Access Compliance Report Public Rights-of-Way (Curb Ramps)

Main Street: DELAFIELD_DR		Cross Street: FAIRHOPE_DR		Location:	N
ADA ID: RPAT210921091344	Ramp Type: Type 4 - Parallel	Initial Pass/Fail: Fail	Overall Compliance: No	Severity Score:	15
Codes/Mitigation Info/Possible Solution			Field Measurements/Component Compliance

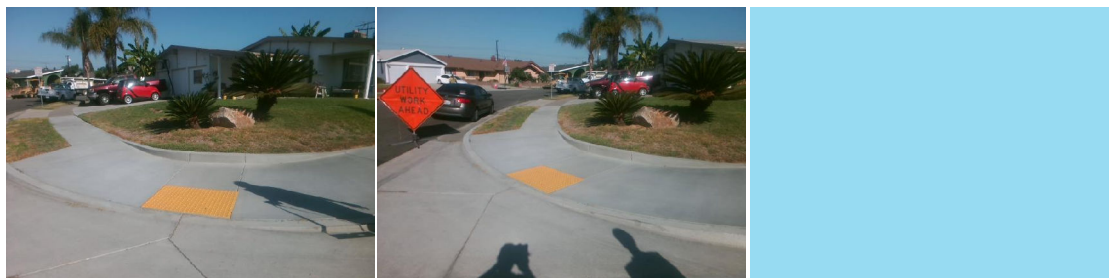
Compliance	Description	Data	Compliance	Description	Data
N/A	Ramp Length LT (in)	100	N/A	Ramp Length RT (in)	100
Yes	Ramp Width LT (in)	97	Yes	Ramp Width RT (in)	100
Yes	Ramp Run Slope LT (%)	6.4	No	Ramp Run Slope RT (%)	8.4
Yes	Ramp Cross Slope LT (%)	0.3	Yes	Ramp Cross Slope RT (%)	1.8
N/A	Landing Present	N/A	N/A	DWS Provided	N/A
N/A	Landing Length (in)	N/A	N/A	DWS Contrast	N/A
N/A	Landing Width (in)	N/A	N/A	DWS Length (in)	N/A
N/A	Landing Run Slope (%)	N/A	N/A	DWS Full Width	N/A
N/A	Landing Cross Slope (%)	N/A		DWS Offset Type	N/A
N/A	Landing Movement Obstructed?	N/A	N/A	DWS Offset Left (in)	N/A
	Landing Movement Type	N/A	N/A	DWS Offset Right (in)	N/A
N/A	Landing Shared	N/A			
N/A	Clear Space	Yes			
N/A	Clear Space To Crosswalk (in)	N/A			
N/A	Marked Crosswalk 1	No	N/A	Marked Crosswalk 2	No
	Crossing 1 Direction	SW		Crossing 2 Direction	SE
	Marked Crosswalk 1 Width (in)	N/A		Marked Crosswalk 2 Width (in)	N/A

Remove & Replace Curb Ramp With Two New Directional Ramps or Equivalent.
